BEFORE THE BOARD OF PATENT APPEALS AND INTERFERENCES

Application Number: 10/692,326 Filing Date: October 22, 2003 Appellant(s): FOOTE ET AL.

EXAMINER'S ANSWER

US: 4,877,217

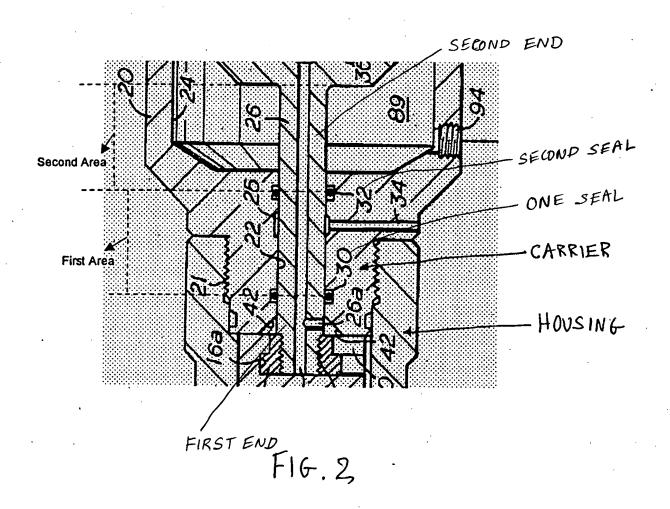
Peil discloses a seal assembly for a reciprocating shaft (intended use) comprising a body having a bore (bore 22), a shaft (shaft 26) that moves reciprocally within the body between an extended position from the body and a retracted position within the body (shaft 26 reciprocates), at least one first circumferential seal (seal 30 seals the shaft) positioned in the body and circumscribing the shaft, the first circumferential seal performing a dedicated seal function of preventing fluids from migrating along the shaft from a first region of the body, the shaft having a first seal travel area (seal area that is contacted by first seal 30) which is in contact with the first seal during axial reciprocating movement of the shaft (portion that contacts as seen in figures 2-3), at least a portion of the first seal travel area extending from the body where it is exposed to contaminants when the shaft is in the extended position (intended use), at least one second circumferential seal (seal 32) positioned in the body and circumscribing the shaft in axially spaced relation to the first circumferential seal (seal 30), the second circumferential seal being dedicated to performing the same sealing function as the first circumferential seal (the seal 32 is capable of sealing the shaft in an event the first seal fails) and serving as a redundant back up seal until the first circumferential seal experiences seal failure (intended use when the first seal fails, but the seal 32 is a redundant seal for preventing fluid from entering the second region), the second circumferential seal being positioned to prevent fluid from migrating along the shaft from

the first region of the body and to maintain the seal at the first end of the shaft in the event of a failure of the first circumferential seal (intended use when the first seal fails and a resultant would occur, the second seal 32 is a redundant seal for the first seal 30), the shaft having a second seal travel area (area of the shaft 26 that only contacts seal 32) which is in contact with the second seal during axial reciprocating movement of the shaft the second seal area remaining sheltered within the body even when the shaft is in the extended position (the second seal area is sheltered in the body, see figures 1-3), the first seal travel area and the second seal travel area being axially spaced separate and distinct areas on the shaft (the first seal travel area is distinct from the second seal travel area), such that damage to the exposed portion of the first seal travel area leading to a failure of the at least one first circumferential seal does not lead to failure of the at least one second circumferential seal, as the second circumferential seal engages the second seal travel area which is separate and distinct from the first seal travel area (as seen in figures 2-3, an outer surface of the shaft 26 between seals 30 and 32 is smaller than the outer surface of the shaft 26 between the second seal 32 and end of 36, see attached figure).

The seal including a seal cluster having a primary seal and a seal carrier (carrier as shown in attached figure 2 and primary seal 30 and 32).

Appellants' argument that Peil does not teach the seal assembly of claim 1 is not persuasive because the rejection above and the attached figure 1 shows that Peil discloses a seal assembly having a body (housing) having a bore (bore in housing that receives shaft 26), a shaft having a first end and a second end (see attached figure), at least one circumferential seal (one seal) contacting a first area (first area indicated in attached figure), at least one second circumferential seal (second seal) contacting a second area (second area indicated in attached figure) which is distinct from the first area, the one and second seals sealing the shaft and body from fluid in area 89 and 45, the first area is also capable of receiving well fluid through port 18 and into cavity 45 where the first area is located (figure 2, extended position), the shaft is also capable of extending (as shown in figures 1 and 2, figure 1 not extended and figure 2 extended position), the seals are redundant seals since the seals have the same function of sealing and the second area is always sheltered in the body as seen in figures 1 and 2.

patentably distinguish the claimed invention from the prior art. If the prior art structure is capable of performing the intended use, then it meets the claim. Furthermore the reference of Peil discloses that the shaft is capable of moving reciprocally (figures 1 and 2 show how the shaft is moving reciprocally), the first area is capable of being exposed to contaminants (when the shaft is extended position in figure 2, the shaft is exposed to contaminants in chamber 45 where the first area is located, column 2, lines 64-65), the second seal is capable of being a redundant seal (the second seal prevents fluid or contaminants from chamber 45 to travel along the shaft to chamber 89 just as the first seal and column 2, lines 40-42) and such the damage to the exposed portion of the first seal travel area leading to a failure of the at least one first circumferential seal does not lead to failure of the at least one second circumferential seal (this is the case since the second seal only contacts the second area, as shown in figures 1 and 2).

1,709,949

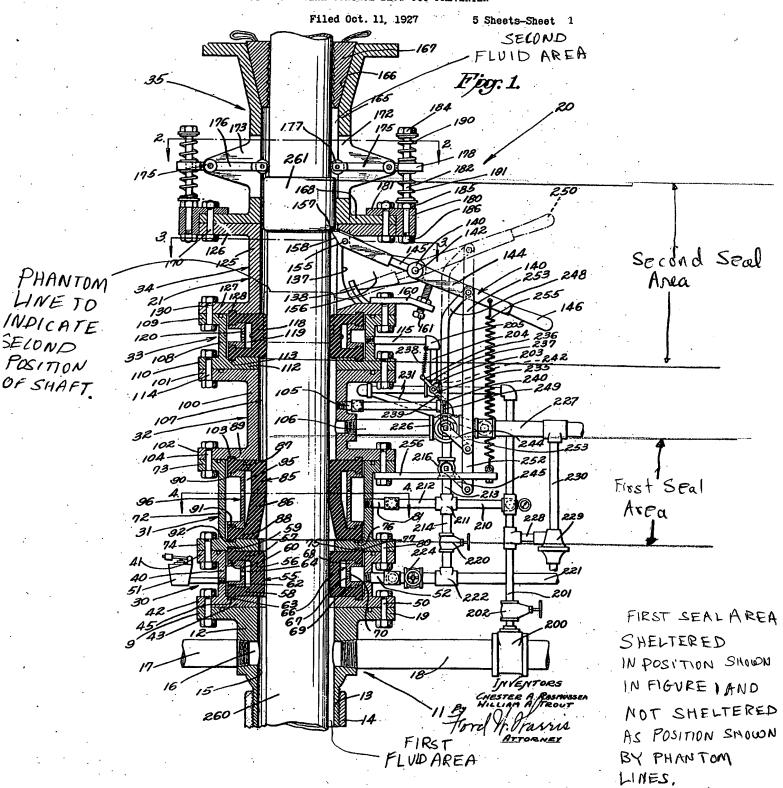
Rasmussen teaches a seal assembly having a body having a bore (body having shaft 260), a shaft (260) that is a ram shaft of a blow out preventer, a first circumferential seal (seal 85) positioned in the body that contacts a first seal area of the shaft (where the first circumferential

seal contacts the shaft 260), a second circumferential seal (either 118 or 55) positioned in the body that contacts a second seal area (where the second circumferential seal contacts the shaft 261) of the shaft that is sheltered in the body and distinct from the first seal area and the second circumferential seal is a redundant seal. The configuration of the second circumferential seal relative to the first circumferential seal prevents a total seal loss of the first circumferential seal and prevents well fluids from flowing past the first circumferential seal in the event of a blow out of the first circumferential seal (this is the case since if the seal 85 fails the seal 55 prevents any fluid from the bottom to flow past the first circumferential seal and the seal 118 prevents any fluid from the top to flow past the first circumferential seal).

Appellants' argument that Rasmussen does not teach the seal assembly of claim 1 is not persuasive because the rejection above and the attached figure 1 shows that Rasmussen discloses a seal assembly having a body (body receiving shaft 260) having a bore (bore that receives the shaft 260), a shaft (260 and 261) having a first end (end near numeral first fluid area, see attached figure 1) and a second end (near second fluid area, see attached figure 1), at least one circumferential seal (85) contacting a first area (first area indicated in attached figure 1), at least one second circumferential seal (118) contacting a second area (second area indicated in attached figure 1) which is distinct from the first area, the one and second seals sealing the shaft and body from first and second fluid area (first and second fluid area indicated in figure 1), the first area is also capable of being exposed to containments (the first shaft is exposed to containments when

the shaft is extended as shown in phantom line in figure 1), the shaft is also capable of extending (as shown in figure 1), the seals are redundant seals since the seals have the same function of sealing and the second area is always sheltered in the body as seen in figure 1.

first circumferential seal does not lead to failure of the at least one second circumferential seal (this is the case since the second seal only contacts the second area, as shown in figures 1).
